COMMITTEE OF ADJUSTMENT REPORT SUMMARY MINOR VARIANCE APPLICATION FILE NUMBER A076/22
---	--

AGENDA ITEM NUMBER: 6.5	CITY WARD #: 1
APPLICANT:	Jagdish, Amandeep & Sarbjit Dhillon
AGENT:	JS Barmi Architect
PROPERTY:	35 Lee Anne Ct Woodbridge
ZONING DESIGNATION:	See below.
VAUGHAN OFFICIAL PLAN (2010) DESIGNATION:	Vaughan Official Plan 2010 ('VOP 2010'): "Low-Rise Residential" and "Natural Areas"
RELATED DEVELOPMENT APPLICATIONS: <small>*May include related applications for minor variance, consent, site plan, zoning amendments etc.</small>	None
PURPOSE OF APPLICATION:	Relief from the Zoning By-law is being requested to permit the construction of a proposed addition to the existing dwelling.

PROJECT TITLE
REAR ADDITION & INTERIOR RENOVATION
35 LEE ANNE COURT
VAUGHAN, ON
JSBA PROJECT# : 2124-01

LOT COVERAGE = 13.19%
(12.84% DWELLING; 0.35% COVERED PORCH)

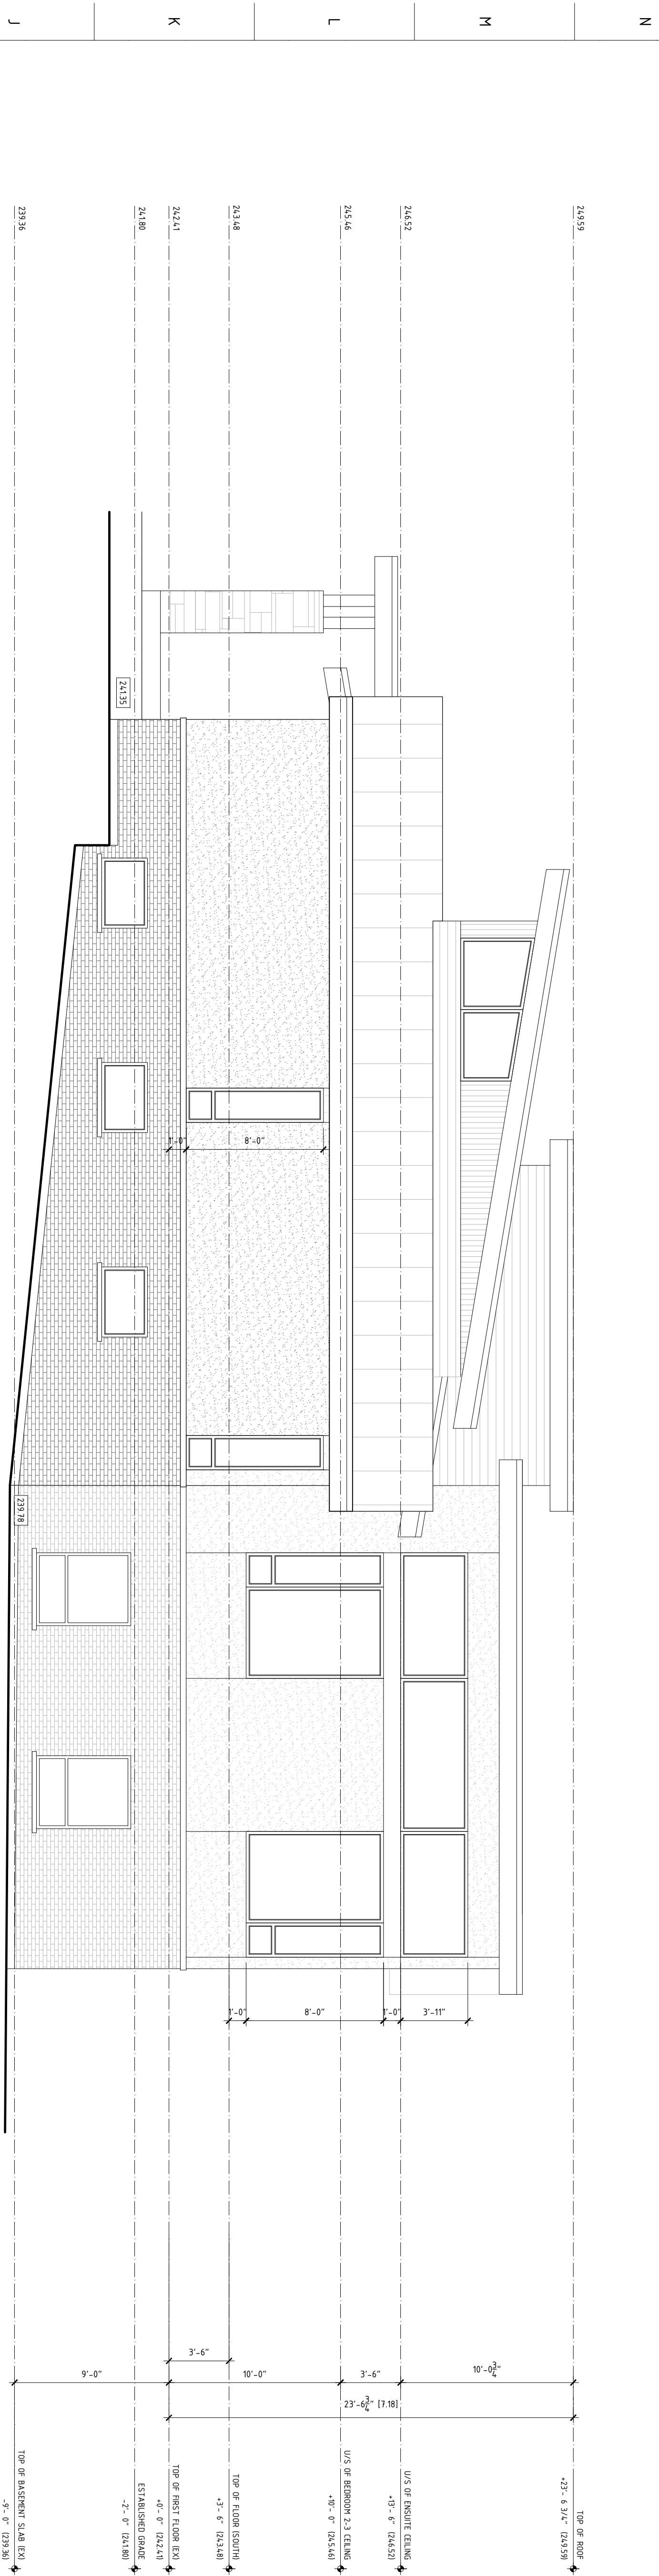
DEVELOPMENT ENGINEERING COMMENTS	
Link to Grading Permit Link to Pool Permit Link to Curb Curt Permit Link Culvert Installation	
<p>On March 3rd, 2022, the property at 35 Lee Court was issued a grading permit, according to Department records. However, the proposed 15.66m2 porch extension at the front of the house was not mentioned in this submission. The owner/applicant must reapply for a grading permit with the City's Development Engineering Department's Development Inspection and Lot Grading division. Please note any in ground structure over 10 m2 requires a grading permit. To clear the condition,</p>

DEVELOPMENT ENGINEERING COMMENTS	
Link to Grading Permit Link to Pool Permit Link to Curb Curt Permit Link Culvert Installation	
please contact the COA application engineering reviewer after receiving the grading permit. (Condition attached)	
The proposed work by the owner is increasing the lot coverage in the subject property. The added hardscape may have impact on City's Storm Water management system. Stuff requires the owner/applicant to introduce Low-impact Development (LID) measures (Bioswales, Permeable pavers, Rain Gardens, Rain Barrels etc.) to reduce the impacts. Please provide DE with a LID brief explaining the measures taken prior to clearing the condition. (Condition attached)	
The Development Engineering (DE) Department does not object to variance application A076/22 subject to the following condition(s):	
Development Engineering Recommended Conditions of Approval:	<p>The Owner/applicant shall submit a revised Lot Grading and/or Servicing Plan to the Development Inspection and Lot Grading division of the City's Development Engineering Department for final lot grading and/or servicing approval prior to any work being undertaken on the property. Please visit or contact the Development Engineering Department through email at DEPermits@vaughan.ca or visit the grading permit link provided above to learn how to apply for lot grading and/or servicing approval.</p> <p>The owner/applicant shall provide a brief to demonstrate the appropriate LID (Low-impact Development) measures and show the measures taken in the drawing to the satisfaction of DE to address the increased lot coverage from 10% to 13.19% in order to mitigate potential impacts on the municipal storm water system.</p>

The proposed dwelling will have a lot coverage of 12.84%, while the proposed covered porch will have a lot coverage of 0.35%. The dwelling coverage complies with Zoning By-law 01-2021, which was enacted by Vaughan Council on October 20, 2021, but has been appealed to the Ontario Land Tribunal and is not in-effect. As such, the Development Planning Department has no objection to proposed variance for increase in lot coverage.

#	DEPARTMENT / AGENCY	CONDITION(S) DESCRIPTION
1	Development Planning joshua.cipolletta@vaughan.ca	That the final Site Plan, Grading Plan, and Tree Preservation Plan be approved to the satisfaction of the Development Planning Department.
2	Development Engineering farzana.khan@vaughan.ca	<div>1. The Owner/applicant shall submit a revised Lot Grading and/or Servicing Plan to the Development Inspection and Lot Grading division of the City’s Development Engineering Department for final lot grading and/or servicing approval prior to any work being undertaken on the property. Please visit or contact the Development Engineering Department through email at DEPermits@vaughan.ca or visit the grading permit link provided above to learn how to apply for lot grading and/or servicing approval.</div> <div>2. The owner/applicant shall provide a brief to demonstrate the appropriate LID (Low-impact Development) measures and show the measures taken in the drawing to the satisfaction of DE to address the increased lot coverage from 10% to 13.19% in order to mitigate potential impacts on the municipal storm water system.</div>
